Narrative for Special Permit # ZBA.2019-96 Amendment

The Special Permit # ZBA.2019-96 for the home renovation project at 59 & 59R Linden Ave was approved in December 2019. However, during the construction process, we encountered several unforeseen challenges, including the site's physical constraints and substantial errors by the previous general contractor, which ultimately led to corrective measures that necessitated minor modifications to the approved plans.

Appendix 1:

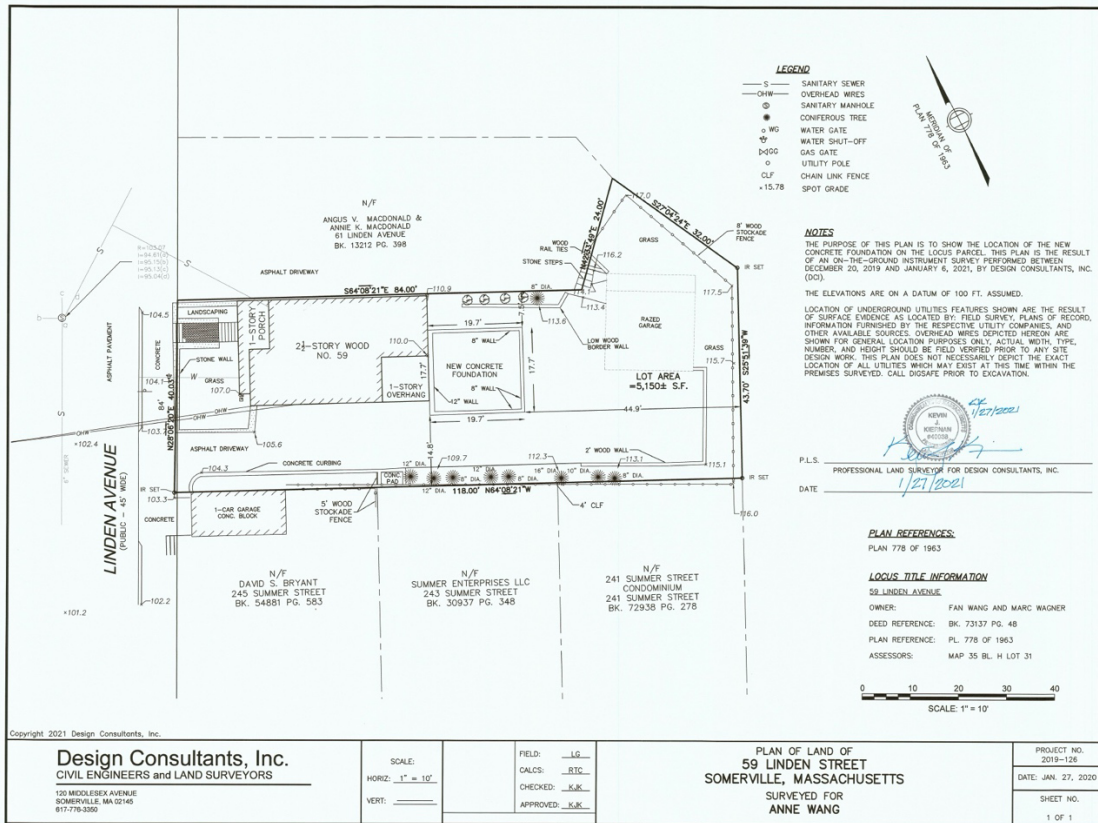
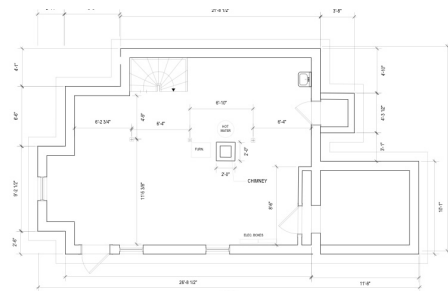
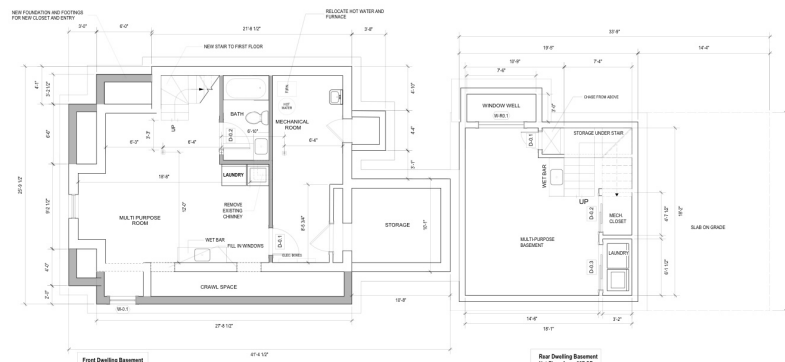
Best Boston Construction and their subcontractors made mistakes in pouring the back unit foundation walls. Despite staking by a licensed land surveyor, the northern foundation walls were poured 2' further south and the east foundation wall 1' further west from the permit plan location. The resulting as-built foundation was 4 feet narrower than design on the NS direction, with incorrect dimension of 19' 7" L x 17' 7" D vs. that in the architectural plan of 19' 5" L x 21' 6" D. Please see **Appendix 1** for a comparison of the as-built foundation vs. the foundation design plan.

As-Built Foundation 19' 7" L x 17' 7" D vs. Architectural Plan Foundation 19' 5" L x 21' 6" D

Appendix 2:

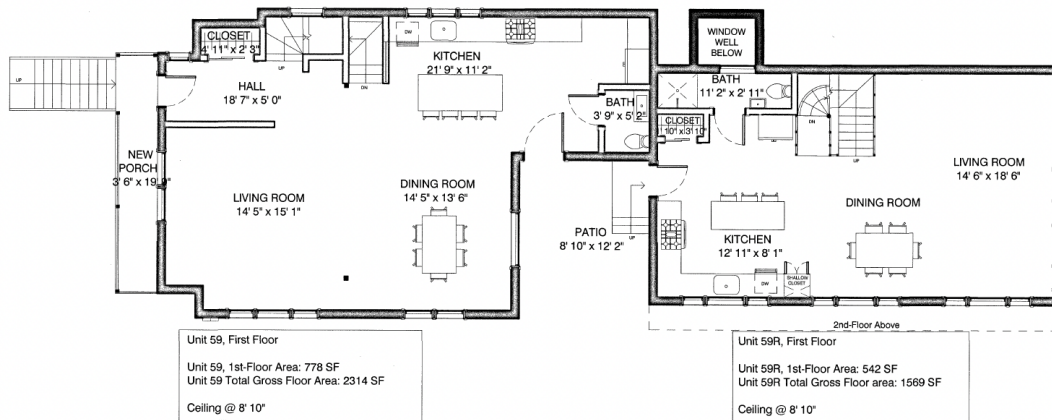
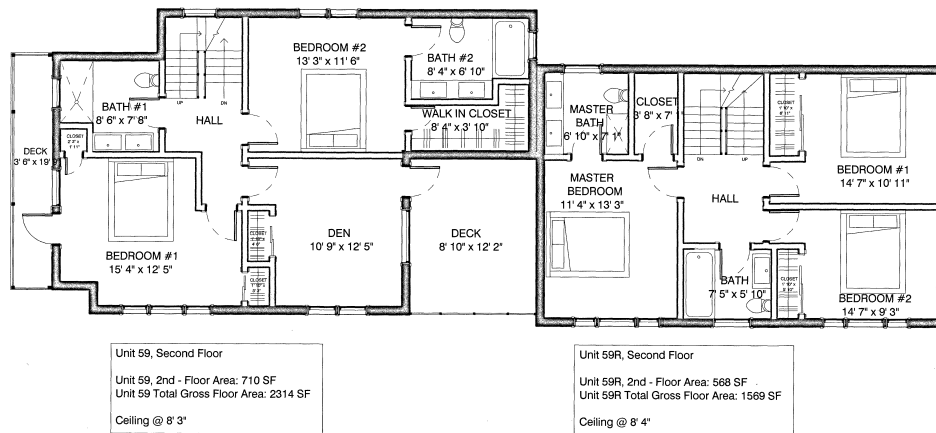
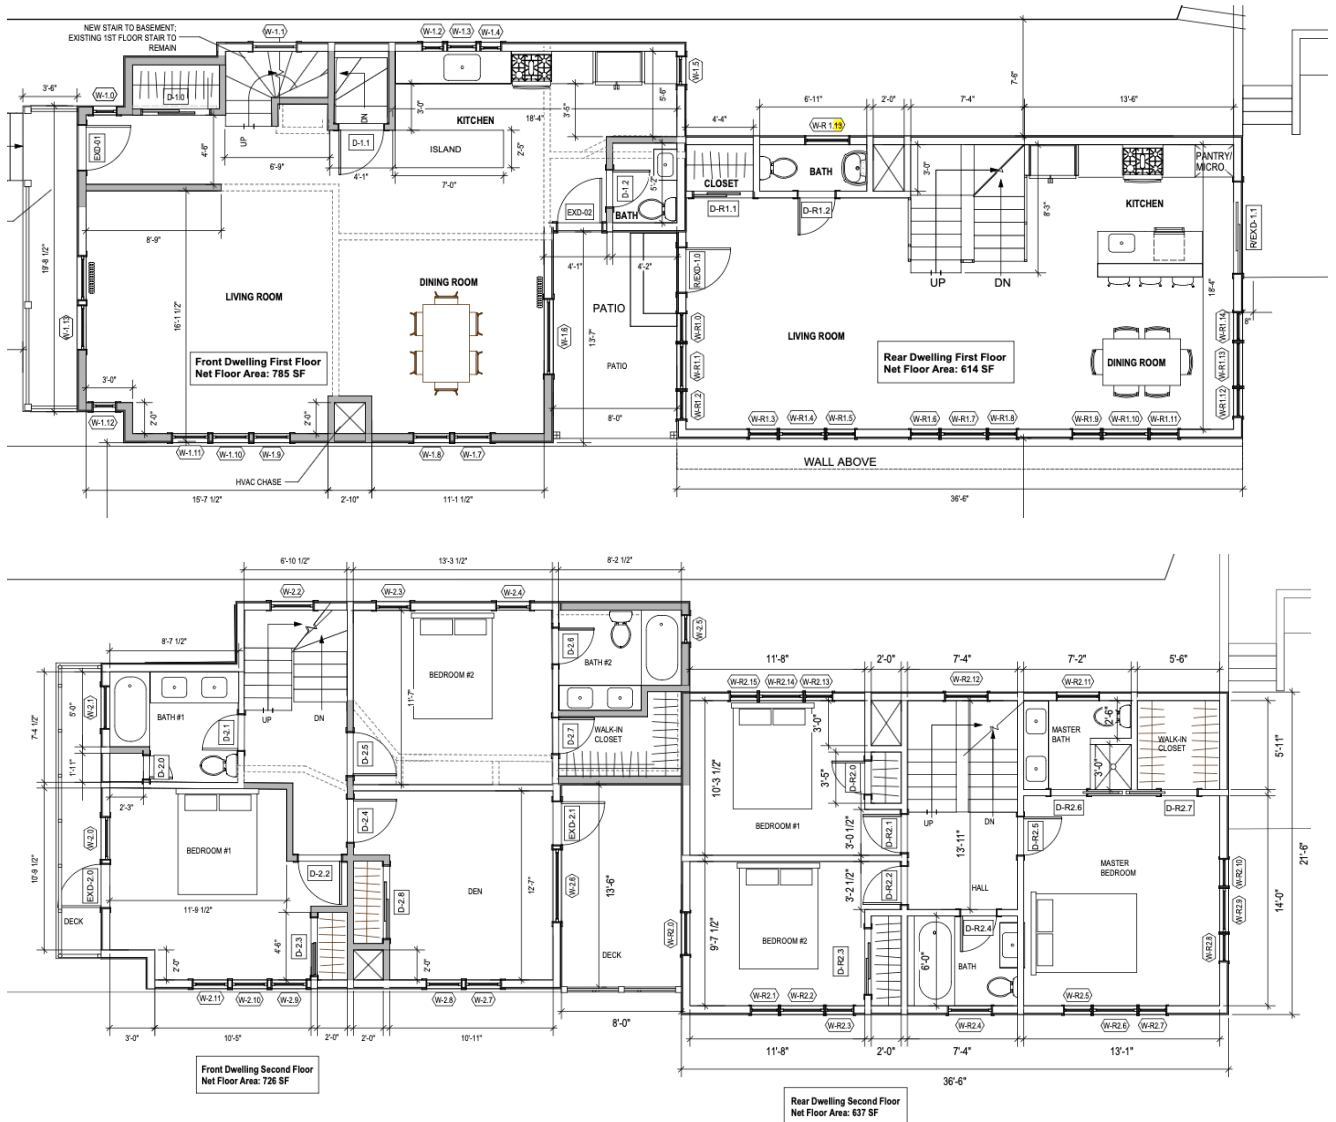
Subsequently, we had to make painful corrections of the rear unit foundation wall deviation and change the upper floor layout. The eventual northern foundation wall of the rear unit is 2ft thicker than by design. Due to structural considerations, the living areas on FL1 and FL2 are 3 feet shorter than the approved permit plan, 33' 10" as built vs. 36' 6" by design. See **Appendix 2** for a comparison of the as-built living space on FL1 and FL2 vs. that by approved design.

Comparison of the As-Built Living Space on FL1 and FL2 vs. that in Approved Design Plan

Appendix 3:
Interior and Exterior Views of the Rear Unit Attic

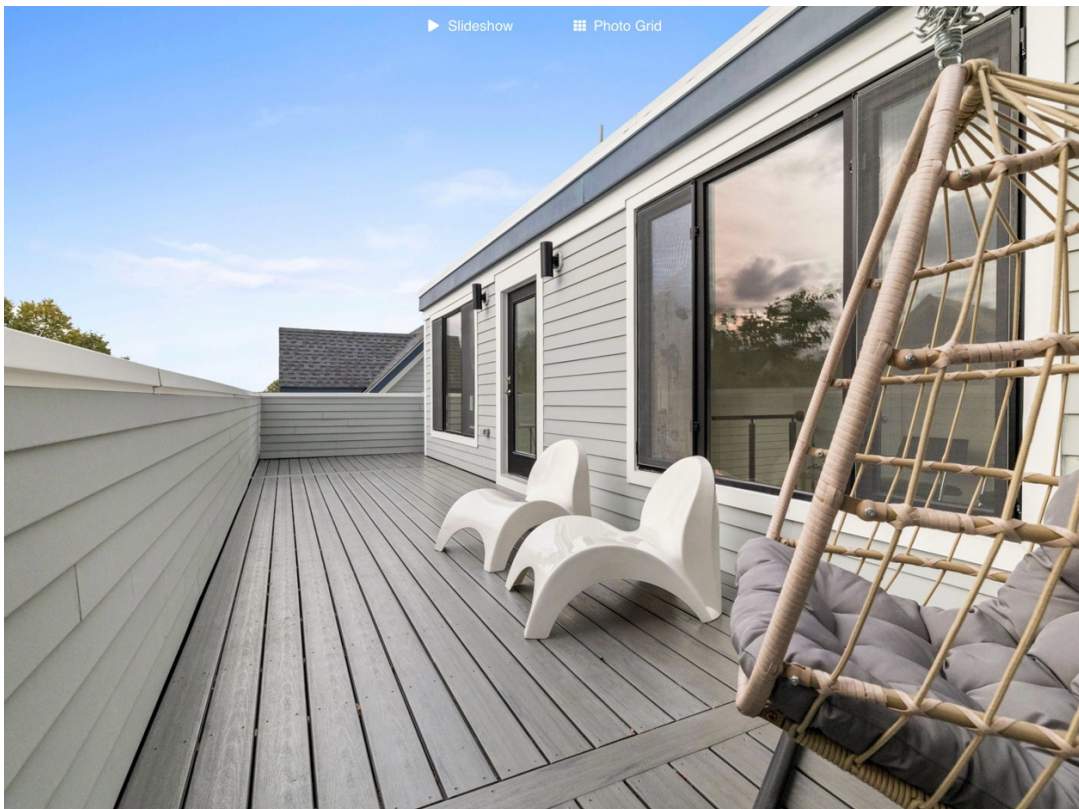
The attic was built larger to partially offset the lost living space by the same size in the lower floors and make the rear unit functional for a family. This expansion of the attic is the least impactful to the neighbors because its shed roof sloping down towards the northern wall and away from the northern neighbor's house. Please see **Appendix 3** for photos of the attic interior and exterior views. Although the attic room is 10ft longer, up to 28ft up from 17ft in the approved plan, the area above 7ft in height is only 3ft wide. Due to the COVID pandemic, small space like the attic is necessary and very valuable for remote work. Multiple inspectors from the City of Somerville went to the building for various inspections over the past years and never raised any objections about the size of the sun room expansion.
